EXISTING FACILITY PRELIMINARY ASSESSMENT REPORT

Waterside at Flathead Lake Condominiums
7175 U.S. 93 South
Lakeside, Montana 59922

Report Date: October 16, 2023

Reported By: Studio Obermeier Sheykhnet Architecture
New Rome Engineering et. Al.

Figure 3-5: Unit 105 (left)

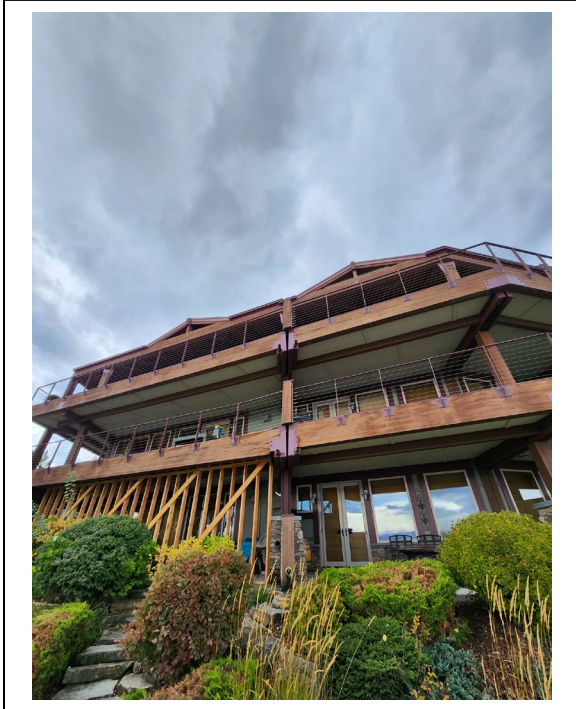
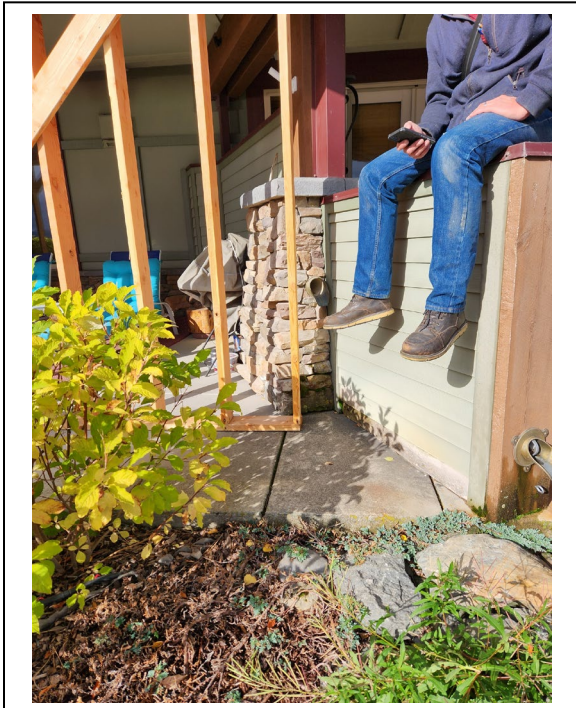
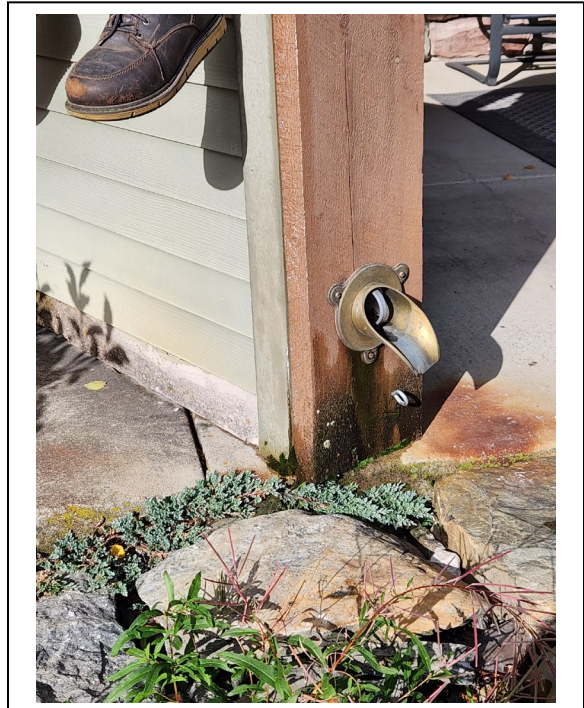
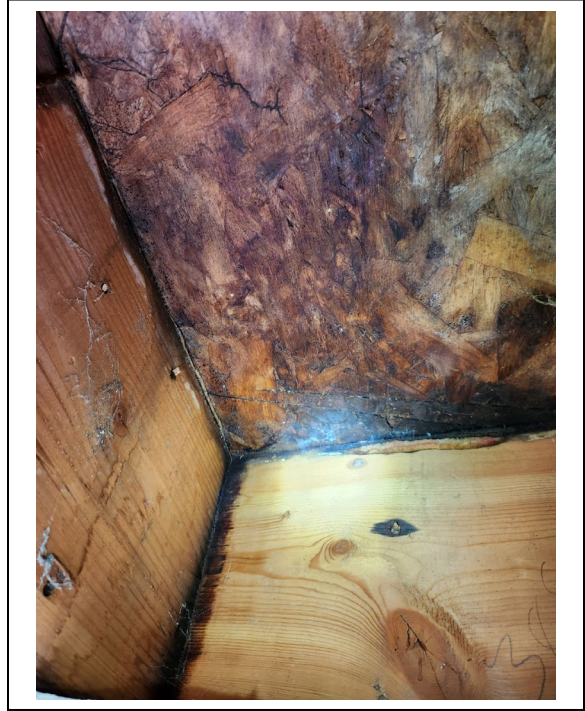
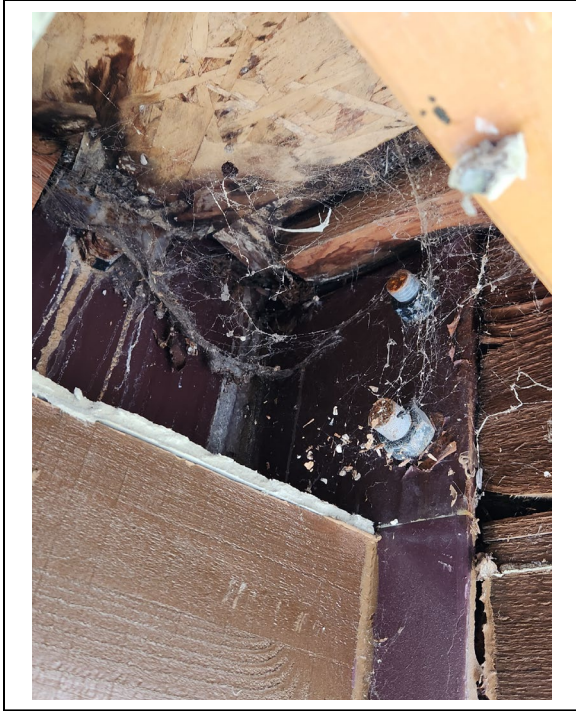
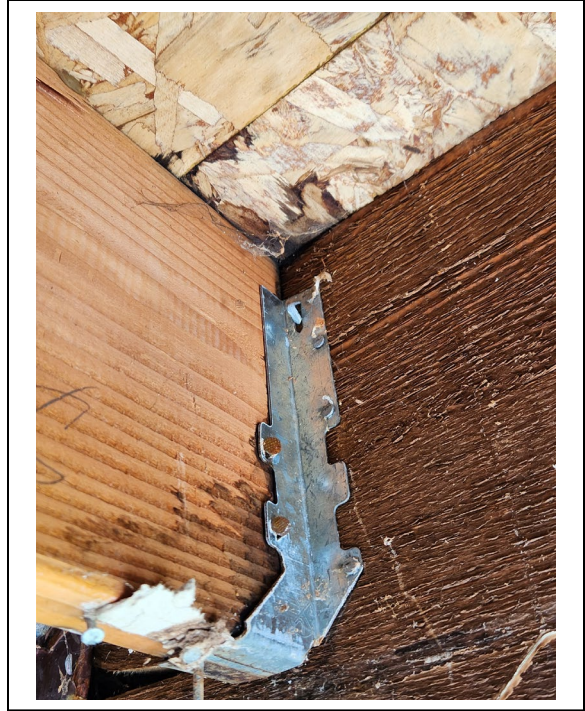
- a. Balcony soffit above Dwelling Unit # 105: (Figures 3-5 thru 3-12)
 - i. Open joist is exposed beyond column line.
 - ii. The second joist from the north is dry rotted- water intrusion is visible near the Balcony divider wall.

Figure 3-13: Unit 205

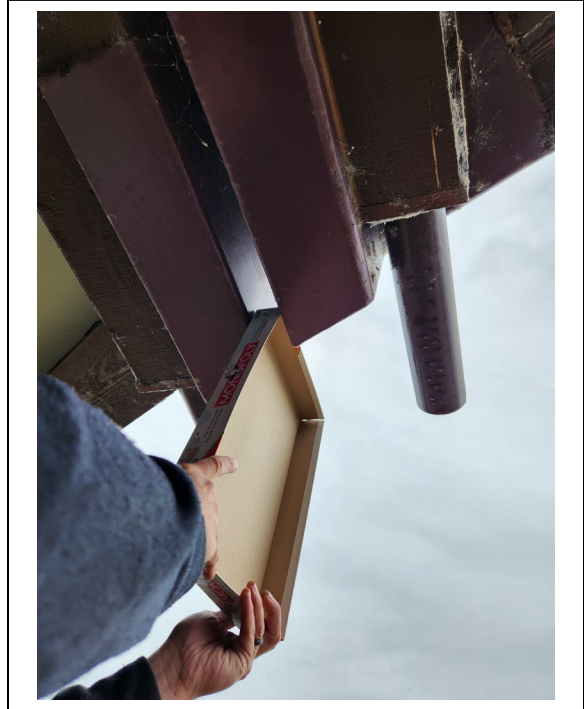
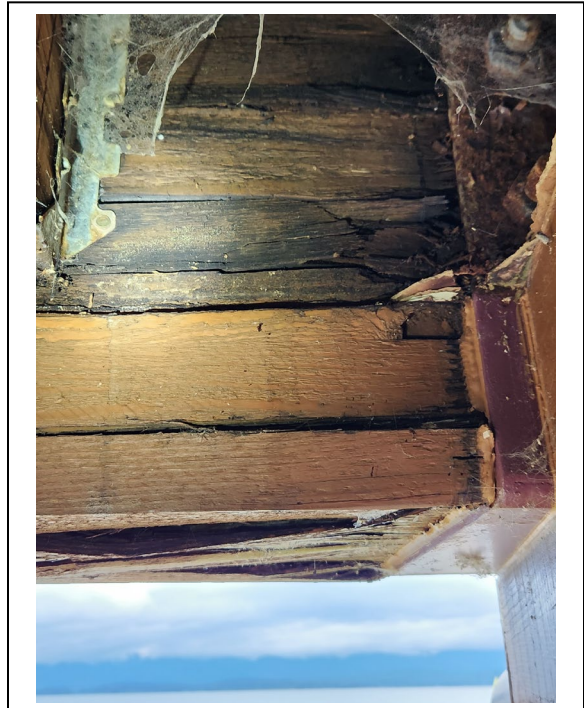
iii. Outrigger beam: (Figures 3-13 thru 3-24)

1. Twisting of the north side: gap is not parallel any longer, wedge assessed at 1.75"+-
2. End of beam covered with steel saddle fitting. Exposed end appears structurally sound.
3. No visible damage to the beam was observed.

iv. Perimeter beam: (Figures 3-13 thru 3-16)

1. Shearing off of the bottom laminations at the north end of near the bottom of the steel saddle plate fitting
2. Glulam is impregnated with waster, moist and soft to the touch.
3. Minor pressure pushes the probe through the softened wood. The beam is structurally compromised - immediate shoring required
4. Glulam beam delamination along adhesion lines appears in multiple locations
5. Storm water is running on the inside face of beam in two locations due to edge of deck detail failure.

Figure 3-17: Unit 205

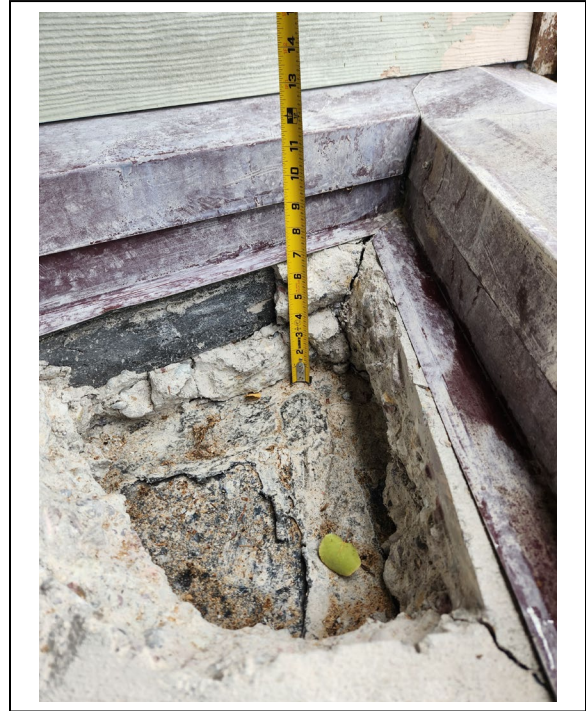
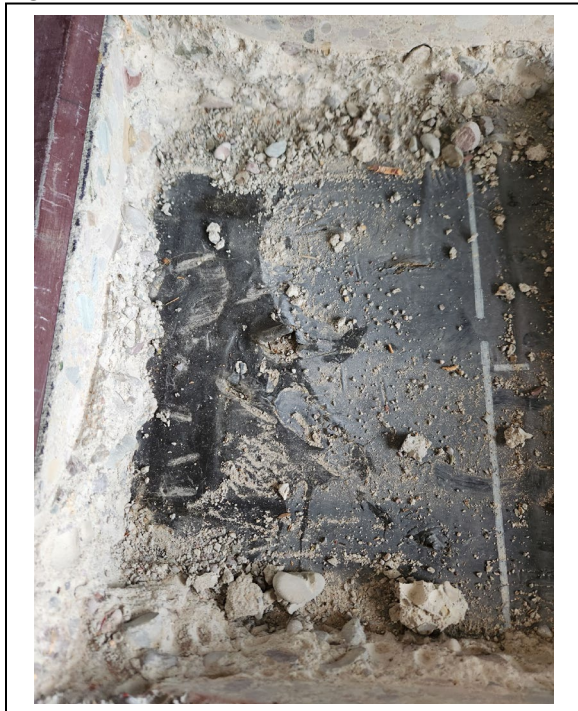
v. Balcony deck (Figures 3-17 thru 3-20)

1. No slope and negative drainage measured at the surface of concrete from edge of balcony to deck drains.
2. Waterproofing membrane adhered to interior face of beam. Beam sagged at mid-point of span. Transition from the horizontal to the vertical plane of the waterproofing membrane assumed to be compromised due to beam movement. Compressible material separating vertical edge of cast-in-place concrete from the waterproofing is holding water to the point of saturation.
3. Failure of edge flashing observed upon removal of flashing.
4. Near 2 water drip locations at the edge of balcony plywood is rotted to location of deck drain
5. Near 2 water drip locations at the edge of balcony the 2x10 wood joists are dry rotted and need replacement

Figure 3-21: Unit 205

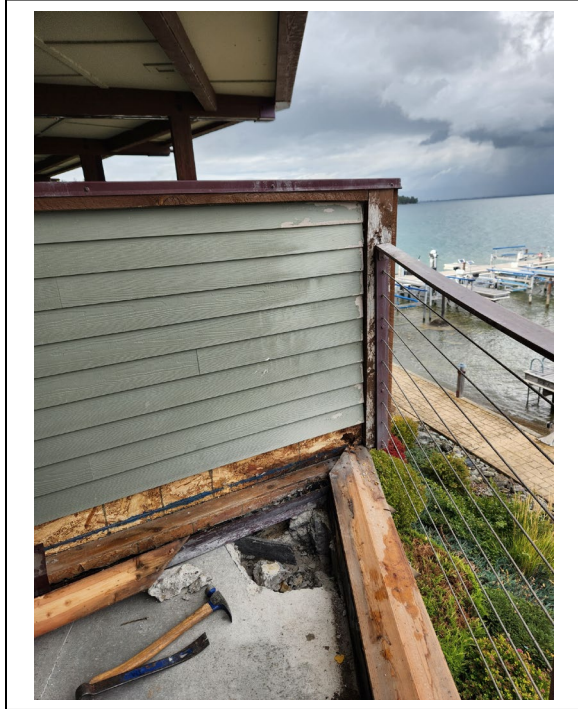
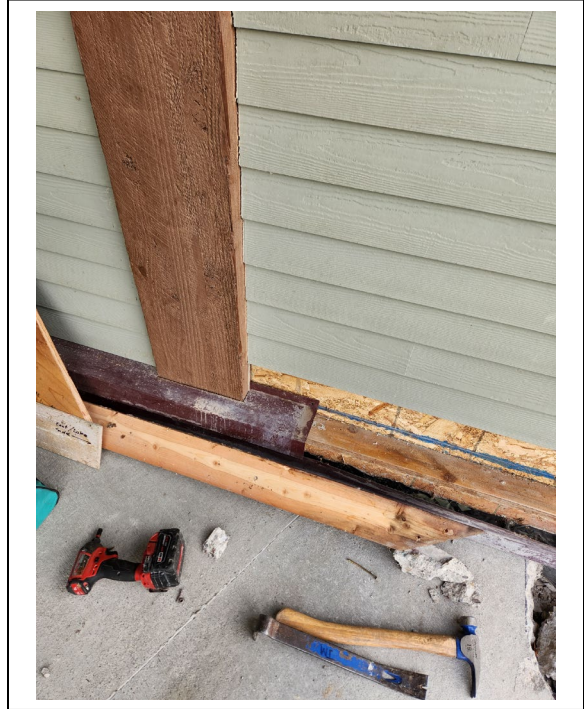
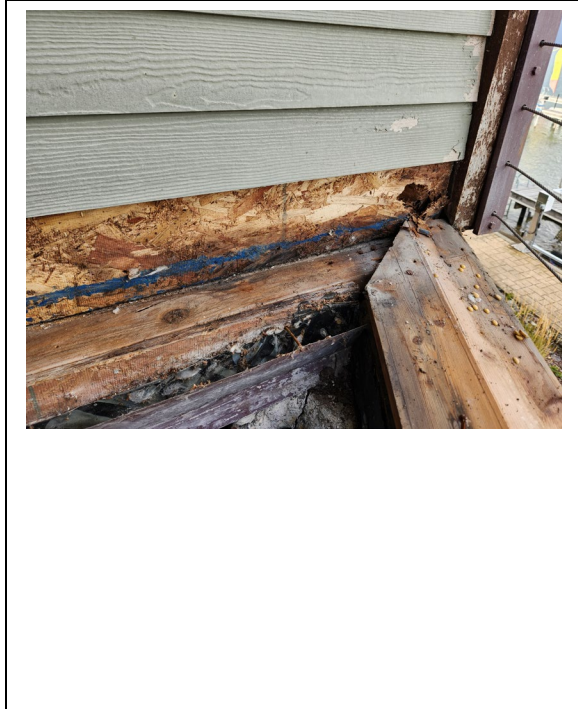
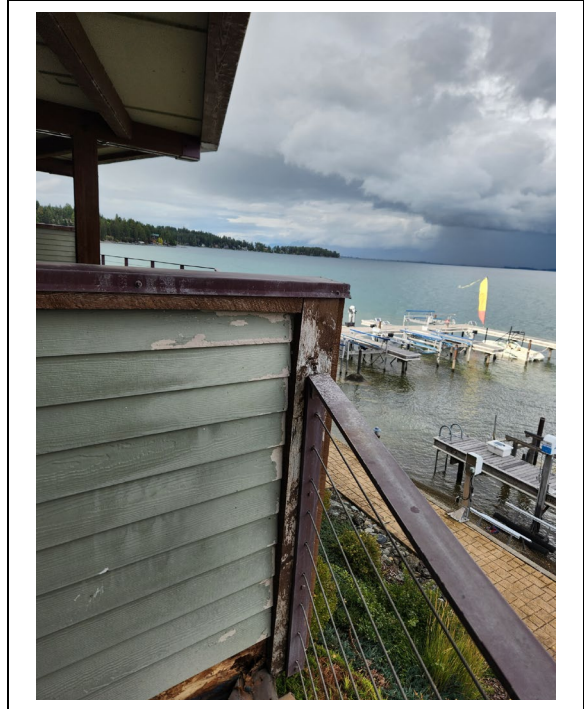
vi. Balcony divider wall on the north side: (Figures 3-21 thru 3-24)

1. Severe water infiltration at the vertical corner at outer south edge of the wall
2. Lateral deck drainage pipe extensions help with leading water away from dropping on top of demising wall, but driven rain and accumulating snow will continue to attach assembly
3. Missing through-wall base flashing
4. Rotted sub-straight discovered upon removal of siding

Figure 3-29: Unit 203

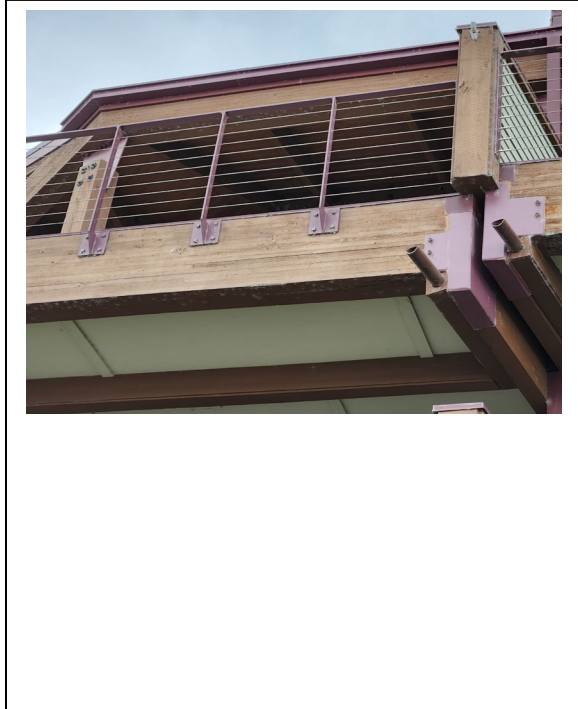
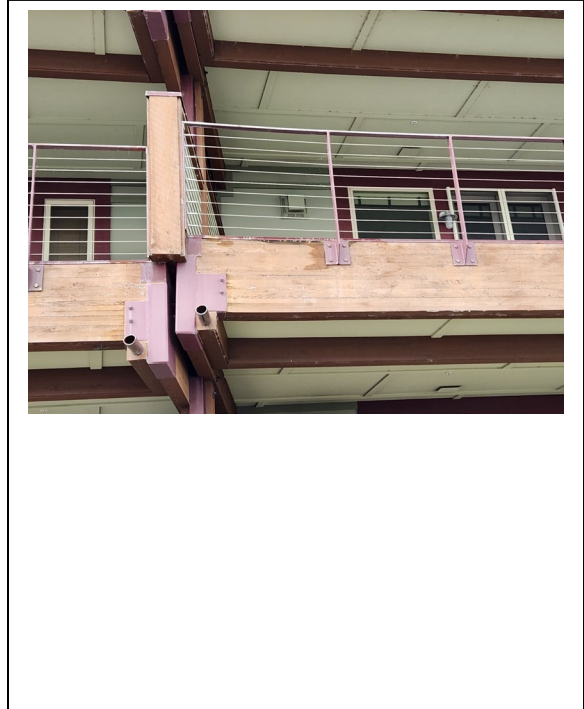
- 2. Discoloration and minor deterioration of the siding material.
- d. Balcony of the Dwelling Unit # 203: (Figures 3-29 thru 3-31)
- xi. Outrigger beam: *(Exhibit A)*

- 1. Twisting of the south side: gap is not parallel any longer, wedge assessed at 1/2"+-
 - 2. End of beam covered with steel saddle fitting. Exposed end appears structurally sound.

- xii. Perimeter beam: *(Exhibit A)*
 - 1. Removed two soffit material panels both sides of the beam.
 - 2. Perimeter beam shows significant deterioration on the south side

- 3. Temporary shoring is needed at perimeter beam south end above and below.
 - xiii. Balcony deck *(Exhibit A)*
 - 1. Condition similar to Dwelling Unit # 205

- xiv. Balcony divider walls: *(Exhibit A)*
 - 1. Observed water infiltration at the vertical corner at outer edge of the wall
 - 2. Discoloration and minor deterioration of the siding material at top and bottom of the wall.

Figure 3-32: Unit 201

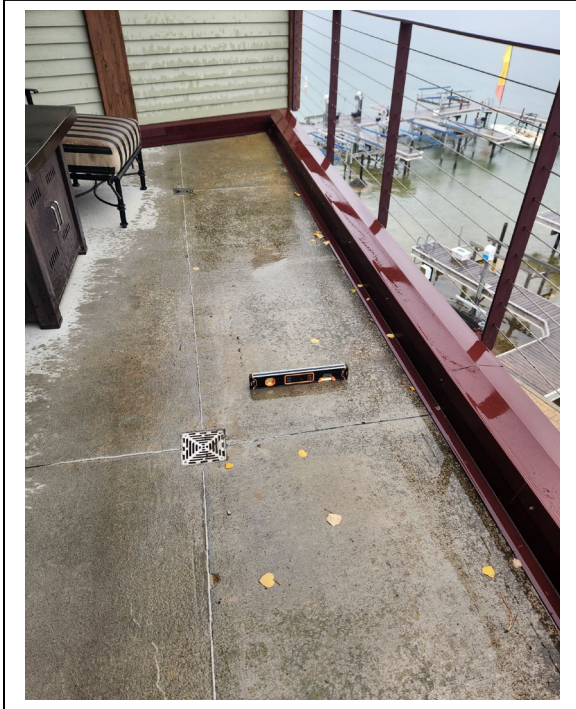
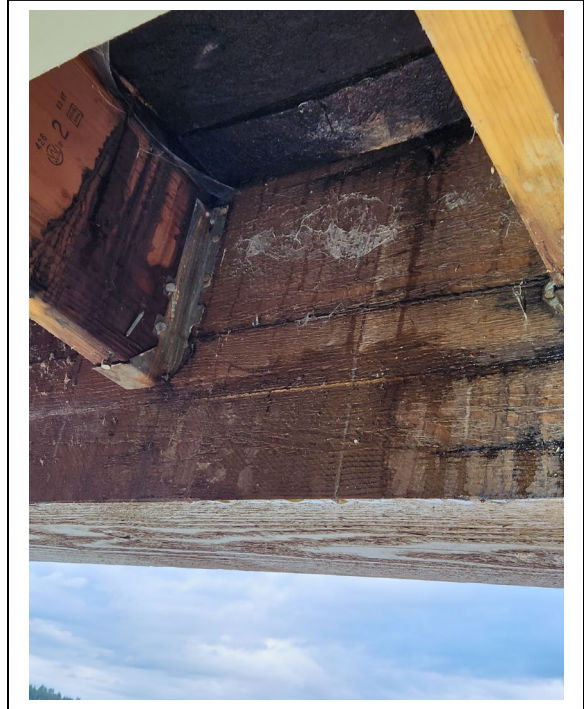
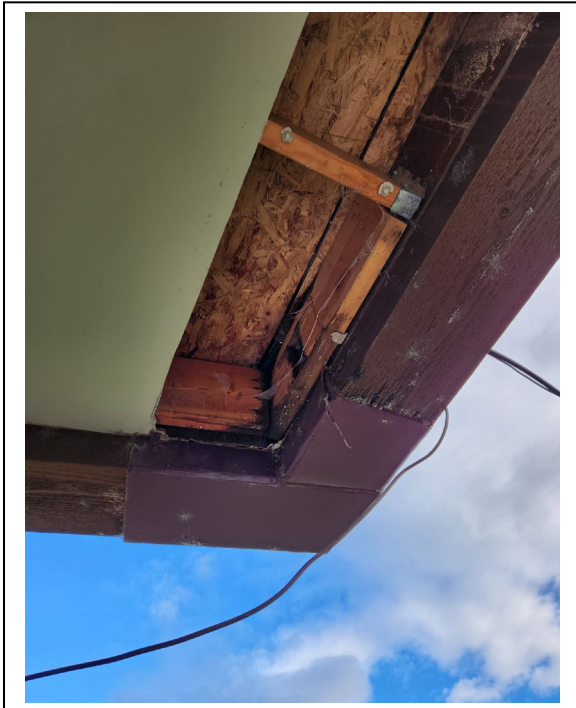
- e. Balcony of the Dwelling Unit # 201: (Figures 3-32 thru 3-35)
- xv. Soffit material removed below the beam on both sides.
 - xvi. Shearing off the end at the glulam balcony perimeter beam by bottom plate of steel saddle fitting observed at south end.

- xvii. Soft and soggy beam's end on the north side.
 - xviii. Beam is compromised and requires temporary support on both ends.
 - xix. South soffit removed. The following observed in the cavity:

- 1. The glulam balcony perimeter beam is soft, soggy with significant loss of structural integrity.
 - 2. The southmost 2x10 wood joist is dry rotted.

- 3. OSB sheathing is blackened and compromised.
 - xx. Dripping of rainwater is observed in two spots off the back of the glulam balcony perimeter beam.

Figure 1-1: Building 1 East Facade

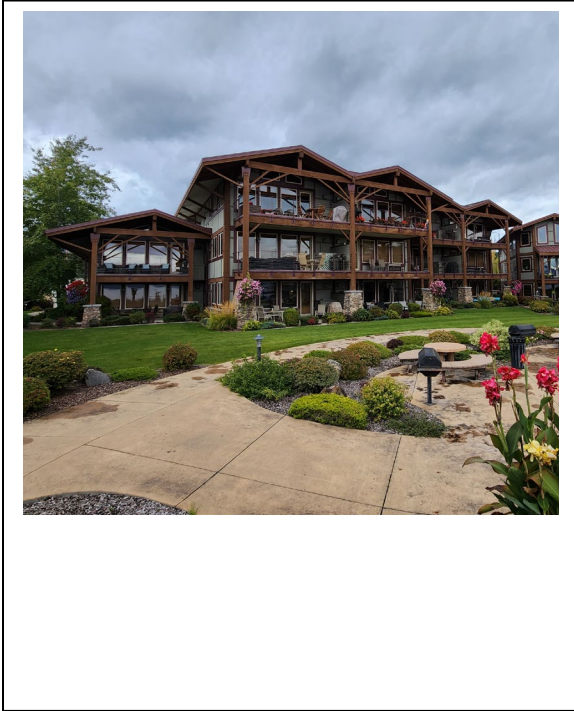
- a. **Building #1:** (Figure 1-1)
 - i. Water absorption by balcony beams due to recent rain was observed at all levels of balcony beams. (Figure 1-2)
 - ii. Balcony beams at dwelling units #204 and #304 are impregnated with water made visible to recent rain. Discoloration & delamination is clearly visible. (Figures 1-3, 1-4)

Figure 2-1: Building 2 South Façade

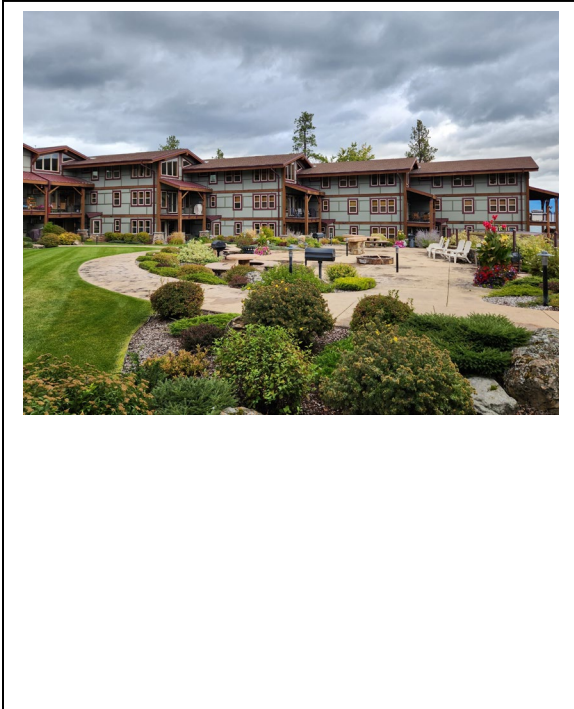
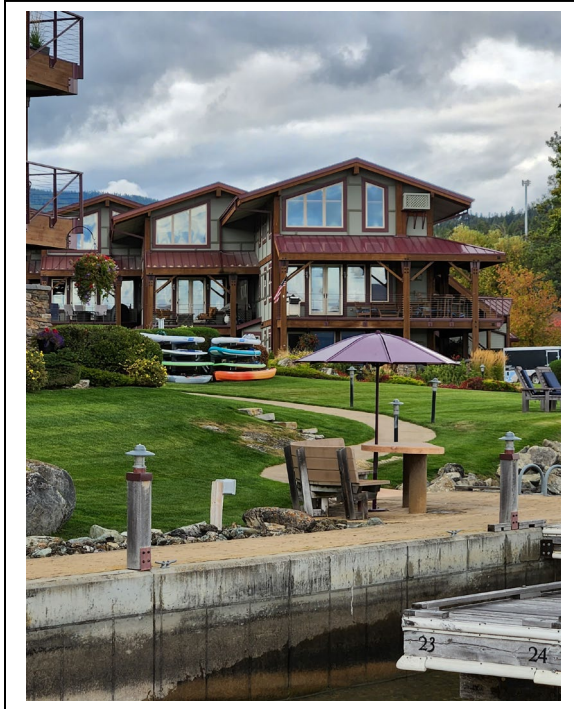
b. Building # 2: (Figure 2-1, 2-2)

- i. Units #201 and #202 balcony roof beams are impregnated with water due to recent rain. Discoloration and staining from prolonged exposure and absorption of water is clearly visible. (Figure 2-3, 2-4)
- ii. Unit 101 and 102 balcony columns show visible signs of absorbing water at bottom stone base, as well as at upper unit balcony roof. (Figure 2-5 thru 2-8)
- iii. Primary roof run-off has been routed just above Unit #202 affected area by a downspout, but terminates on the balcony roof, resulting in added runoff at balcony roof edge. (Figure 2-3)
- iv. Catching runoff required from the water collection area (roof) to discharge point on the ground (splash block at ends of downspouts).
